Mosharaf Apparels Studio Limited

12th & 18th August 2021

Building Information

Observations

Pile Capacity Calculation (soil test report AB Soil & Foundation Engineers dated March 2016)

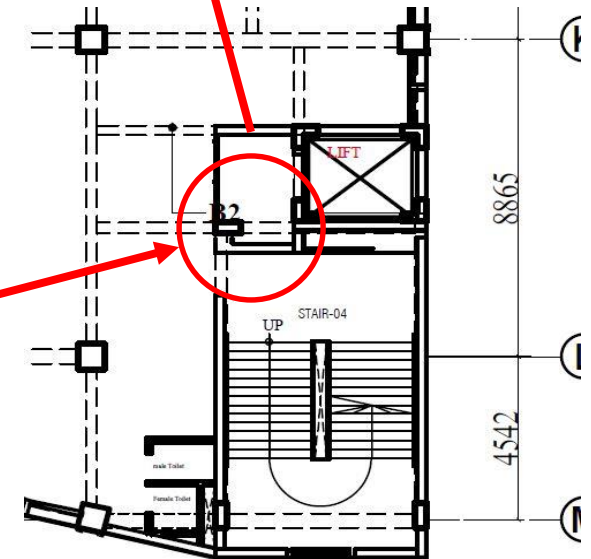
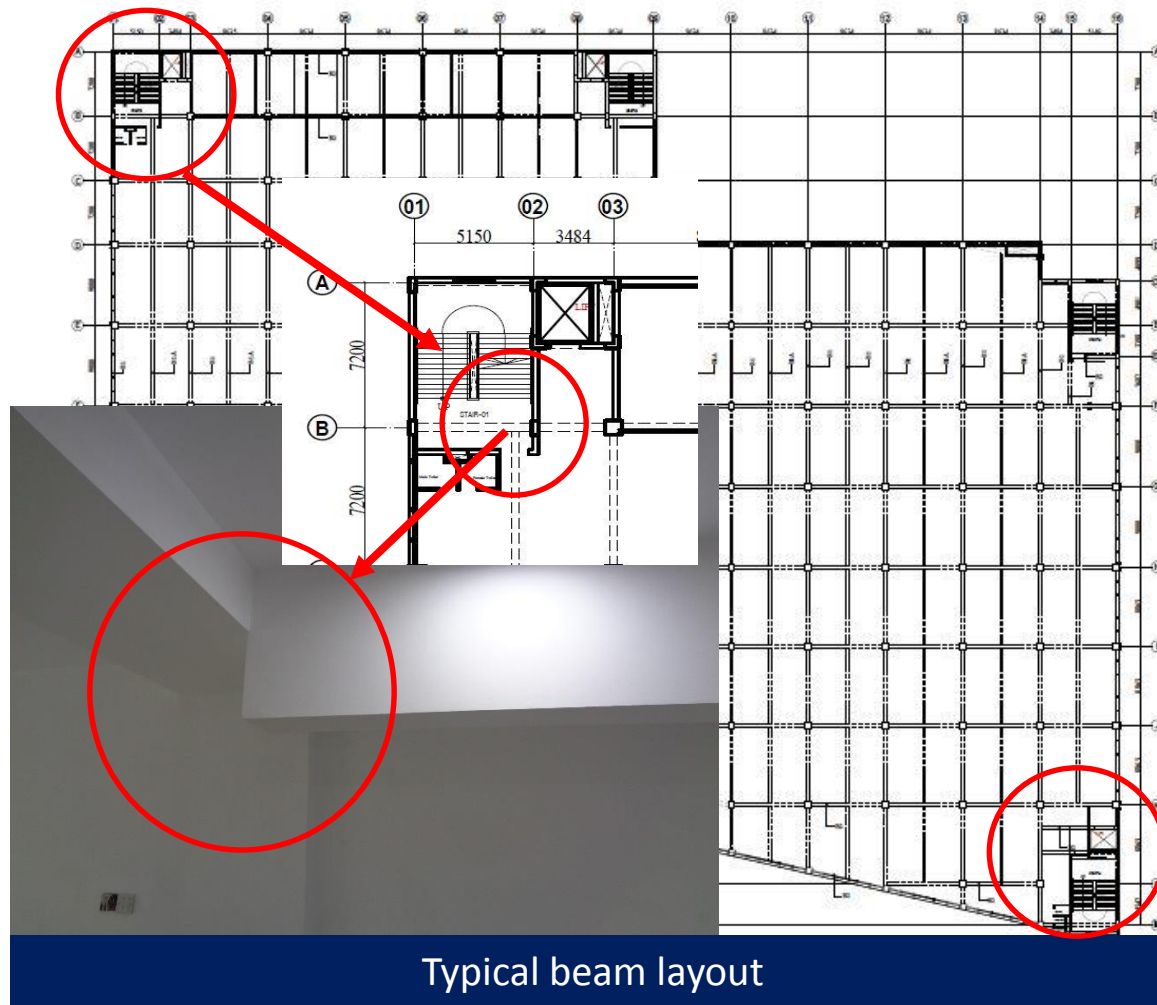
Capacity Calculation of pre-cast pile included in DEA report in reference to another soil investigation report (AB Soil & Foundation Engineering) which was not available during inspection.

Factory is required to verify the foundation adequacy as per the actual foundation type & capacity. Also, justify the geotechnical investigation report.

Falling hazard on 4th floor

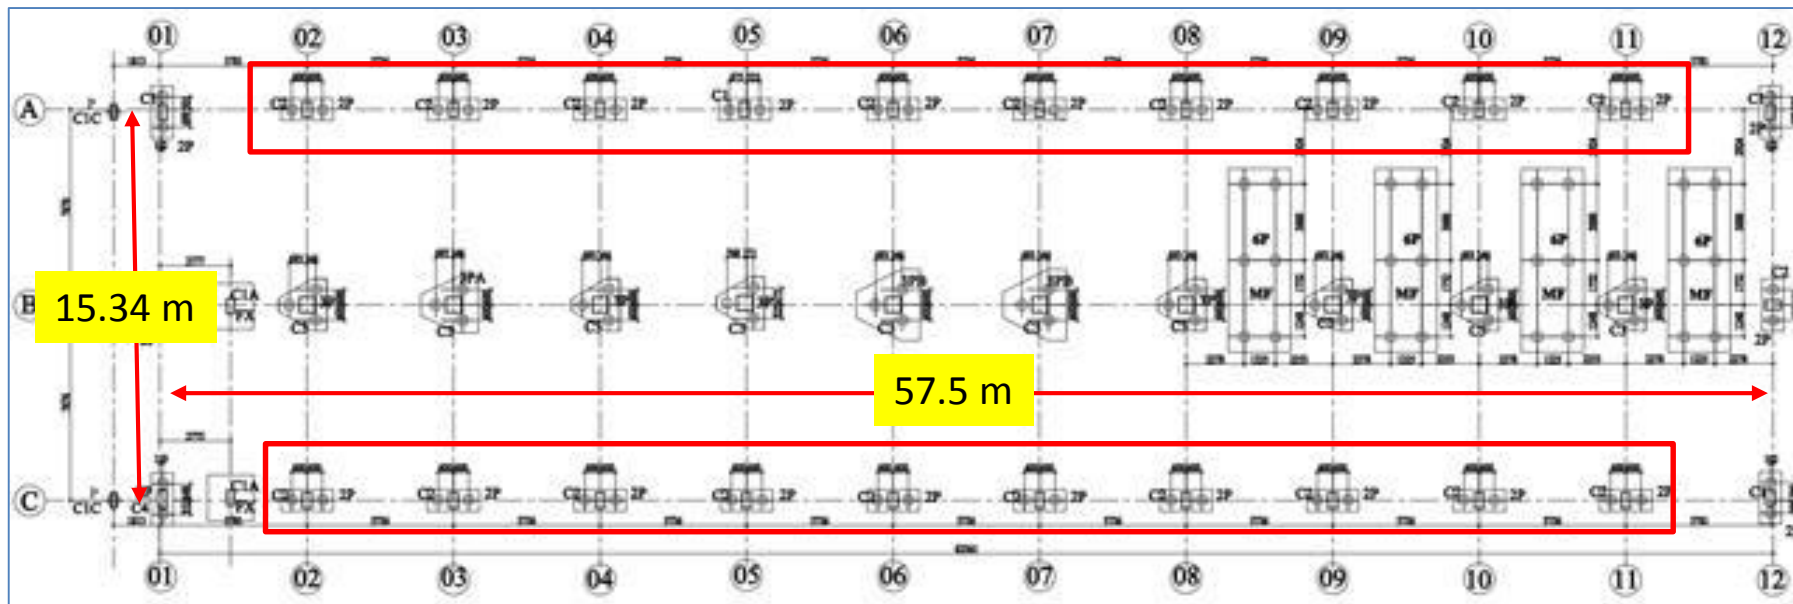
No periphery wall was found near North-West stair on 4th floor. Factory is required to provide adequate protection to avoid possible falling hazard.

Heavy Machin on 1st floor

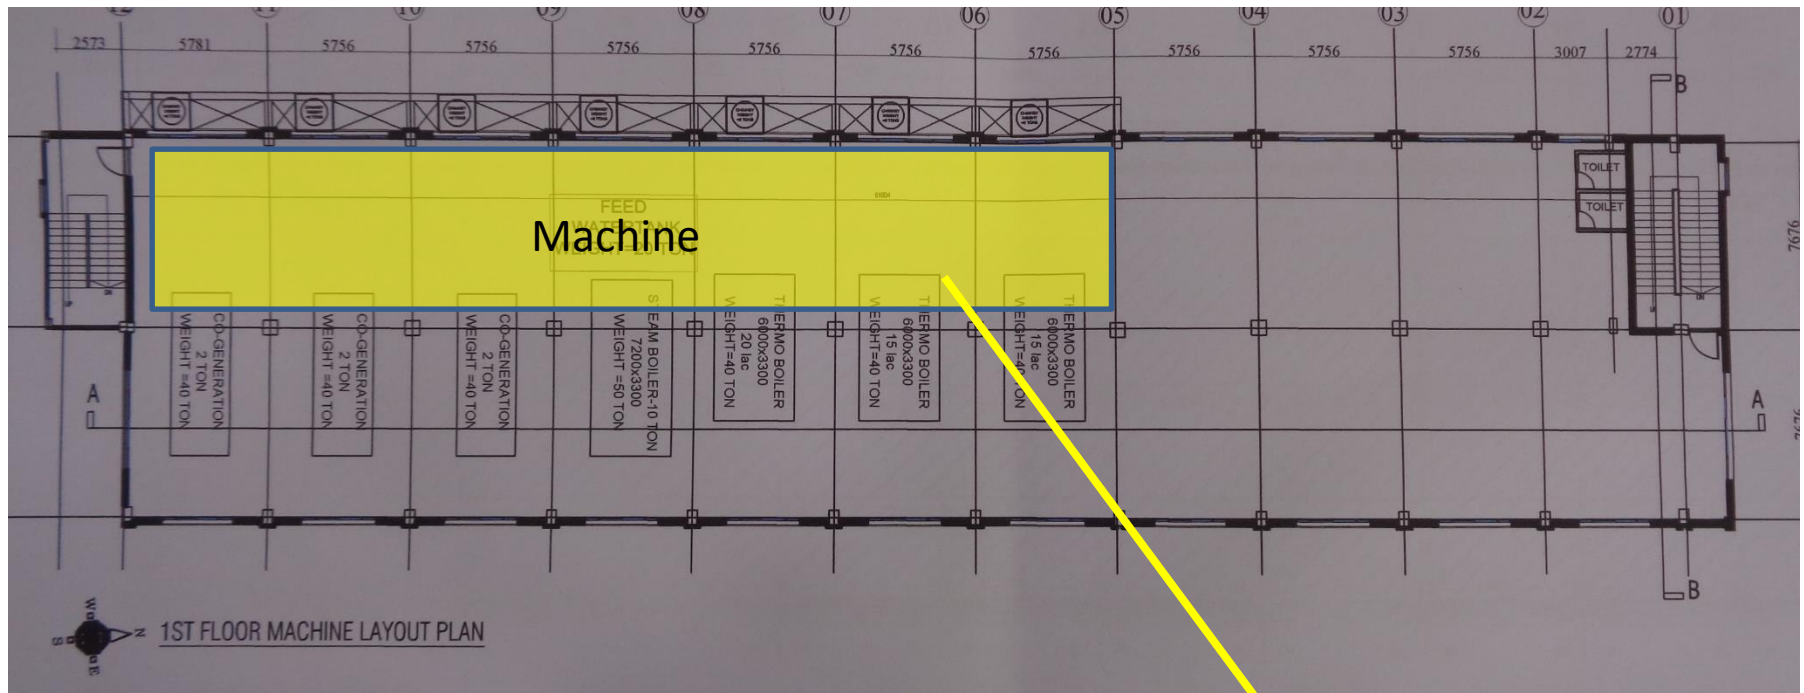
Live load for 1st floor is considered as 5 KPa but live load was found more than 5 kPa on that locations due to heavy machineries. Factory engineer is required to verify and update the live load plan as per site condition.

Heavy Machin on 1st floor found at west side

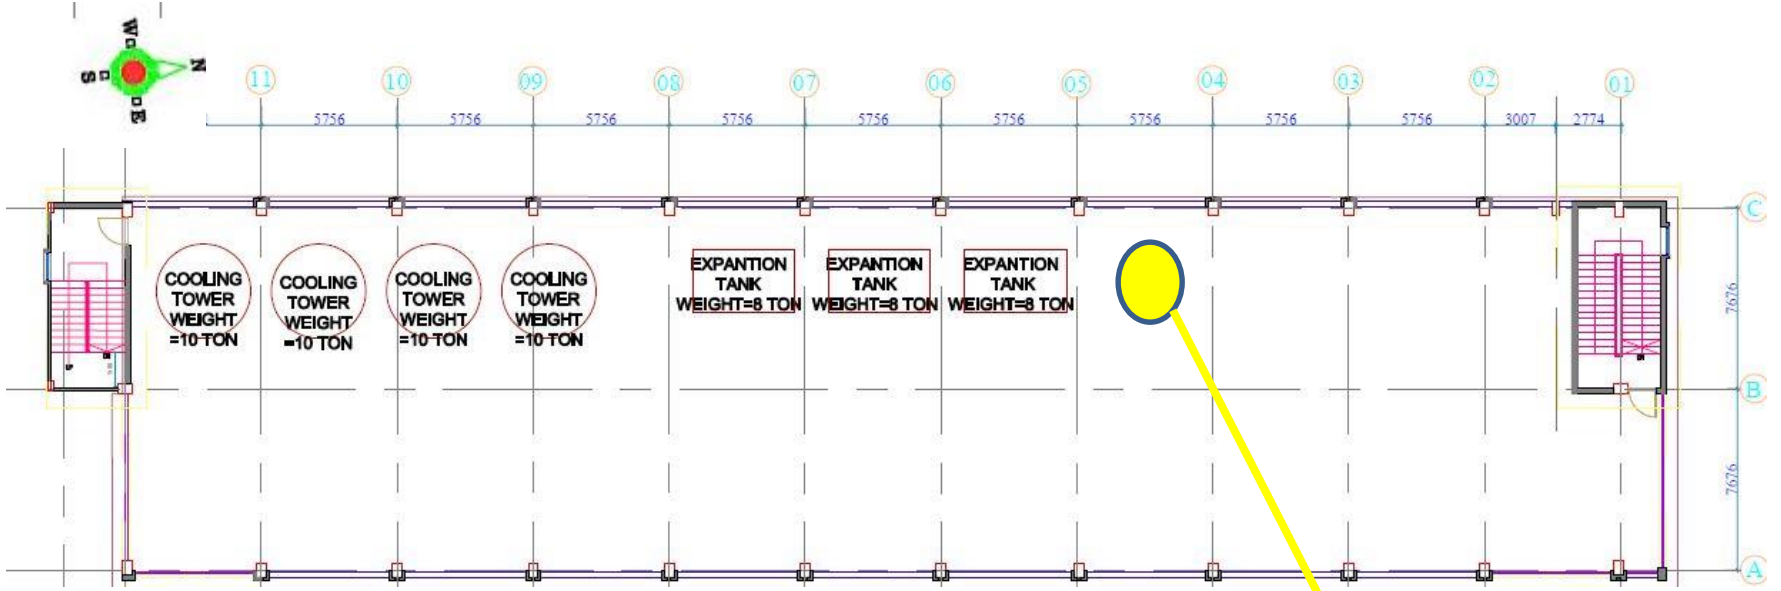
Heavy machineries on 1st floor was shown at east side in floor layout but found at west side of the floor. Factory engineer is required to update the as-built drawing as well as load plan.

Plastic water tank of 3000 liter

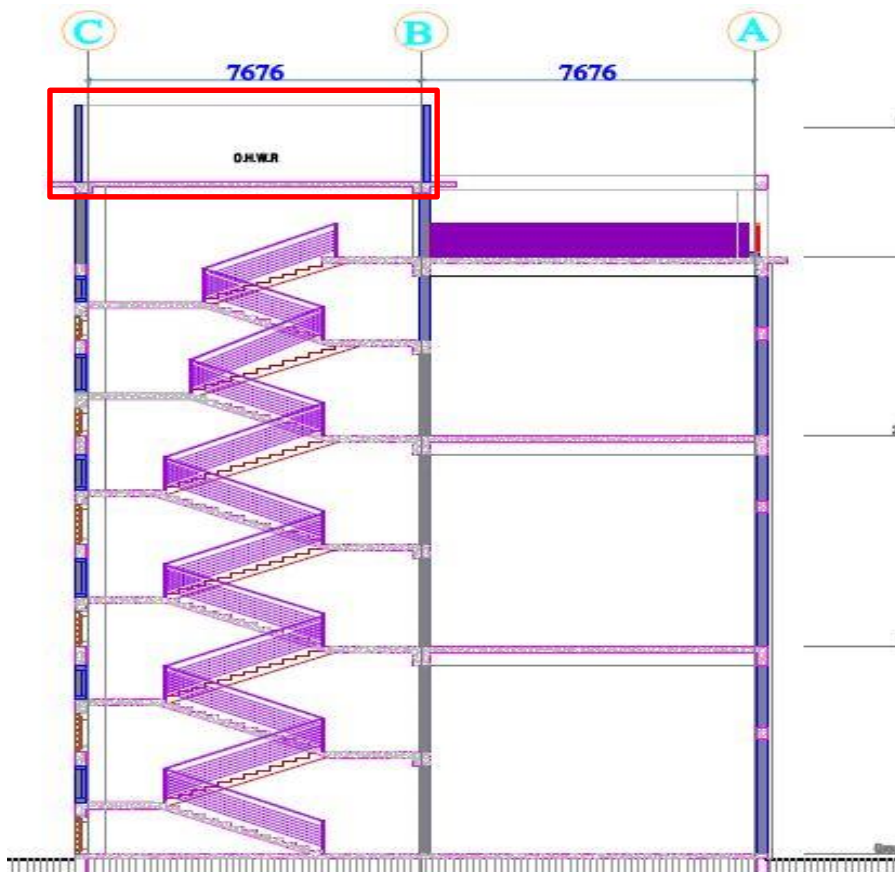
A plastic water tank having capacity of 3000 liter was found on roof slab which was not shown in as-built drawing. Factory engineer is required to update the as-built drawing as well as load plan.

No overhead RC water tank on staircase roof.

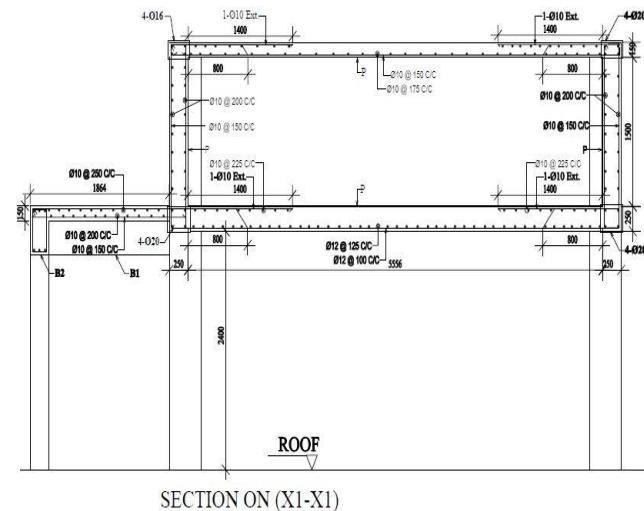
Overhead water tank section shown in as-built drawing, but no overhead RC water tank found on staircase roof. Factory engineer is required to update both as-built architectural and structural drawing.

Water stagnant on roof slab

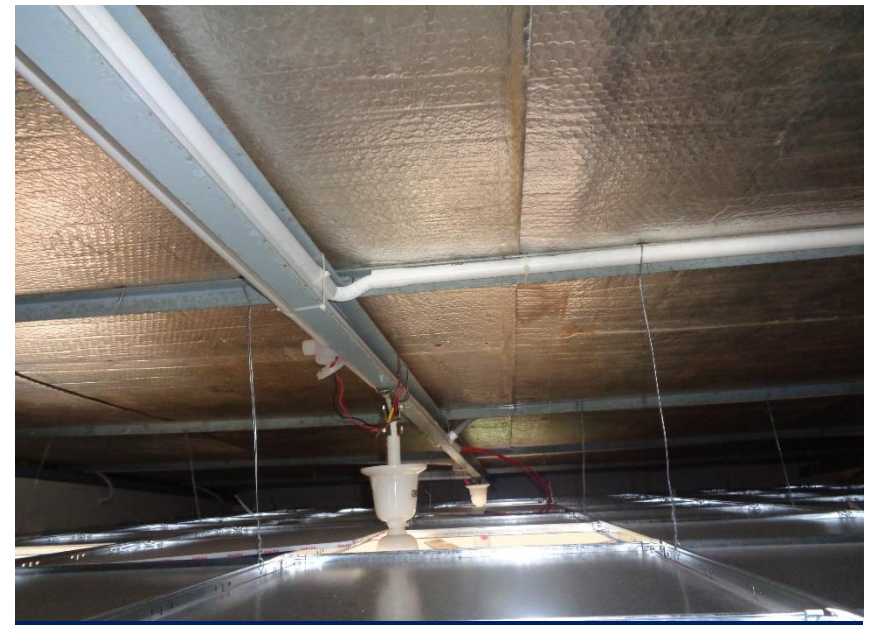
Water stagnant was found on roof slab due to improper drainage system. Factory is required to provide necessary slope and improve drainage system to prevent water ponding.

Provided architectural plan

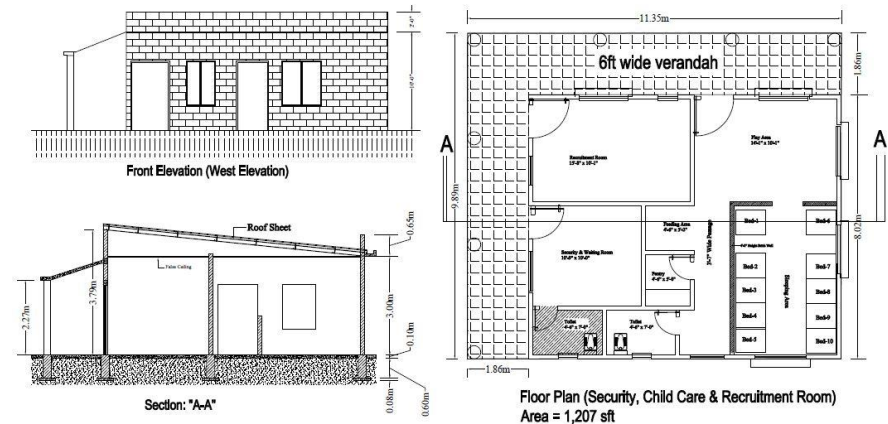
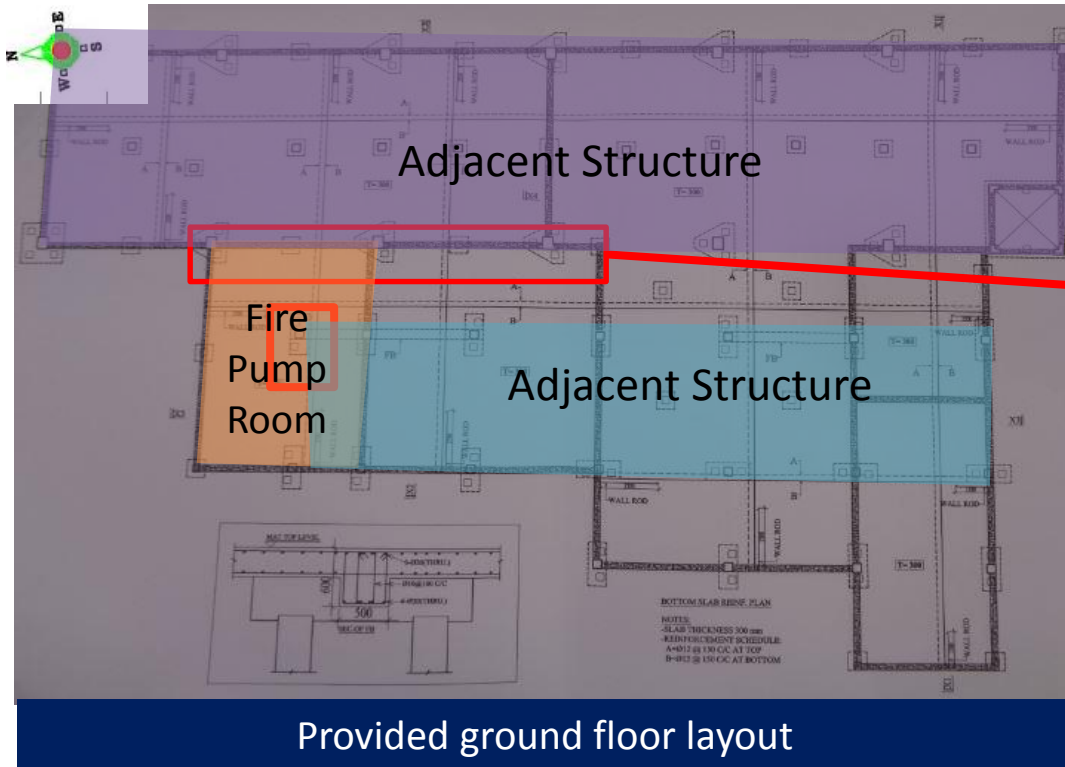
Only an architectural plan was provided by the factory, but no structural drawing were available. Factory engineer is required to produce full set of as-built structural drawing.

Provided ground floor layout

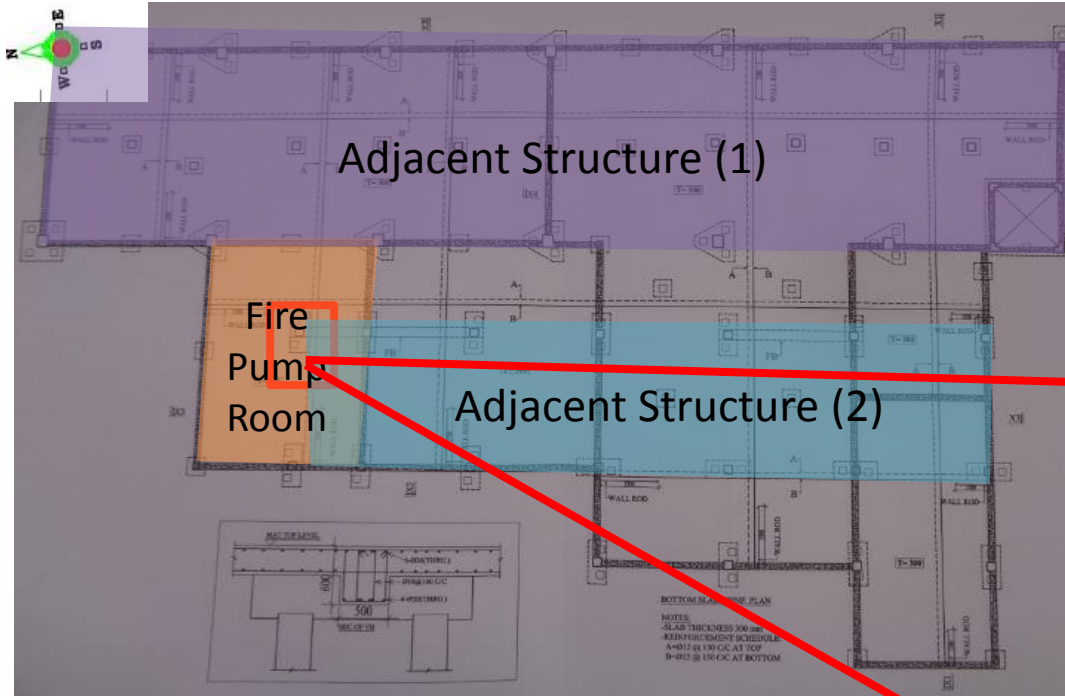
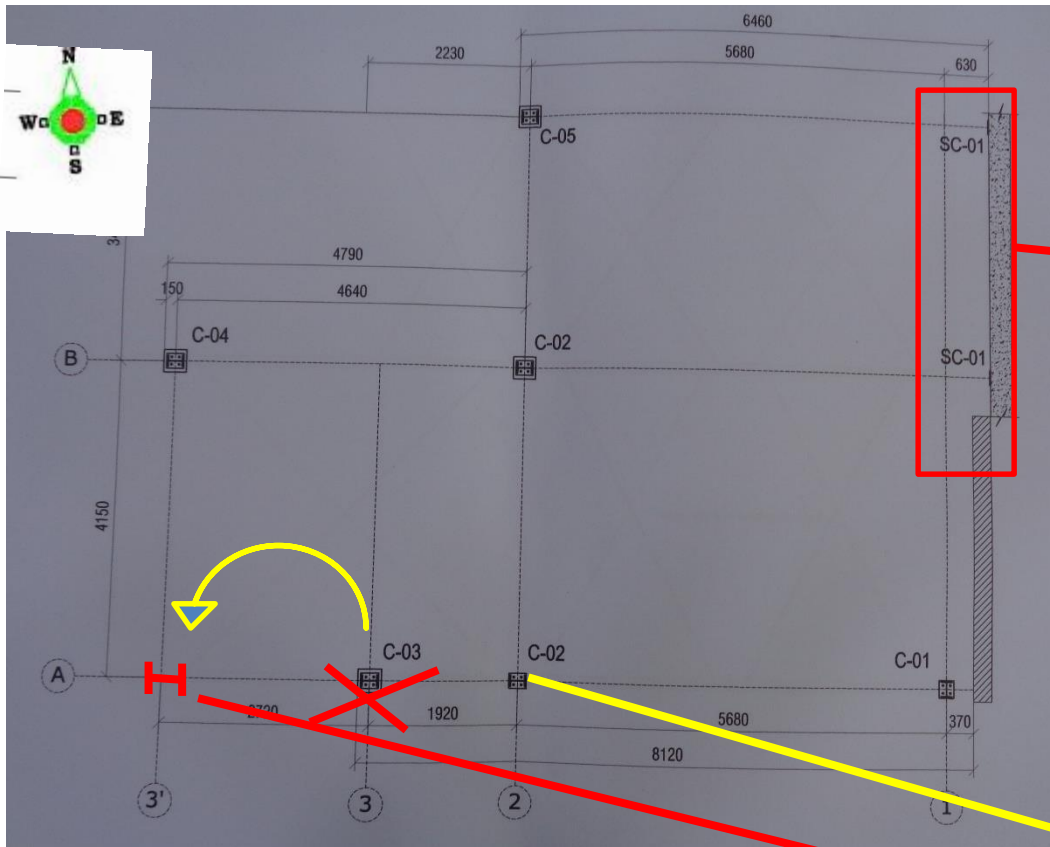
Grade beams of Fire Pump Room structurally connected with the grade beams of the adjacent buildings. Also, rafter of shed is resting on corbels of adjacent building

Fire pump room is located under the north-east corner of adjacent structure (2). The main column of fire pump room is the corner column of that building. Provided ground floor slab indicates that Fire Pump Room is structurally connected with adjacent buildings at grade beam level. No geotechnical investigation report was available for this area. Therefore, foundation adequacy could not be verified. Factory engineer is required to verify the structural integrity and the foundation system for the Fire Pump Room.

Provided Ground floor slab detail

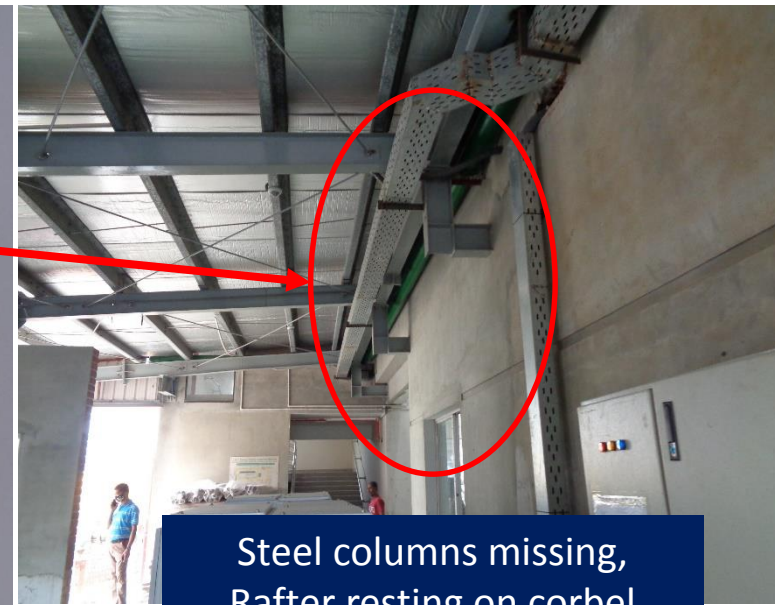
No structural detail was available for the column and beam, RC wall and foundation. One steel column found at different position and two steel columns were found missing. Also, no rafter layout was shown in drawing. Factory engineer is required to produce full set of as-built structural drawing.
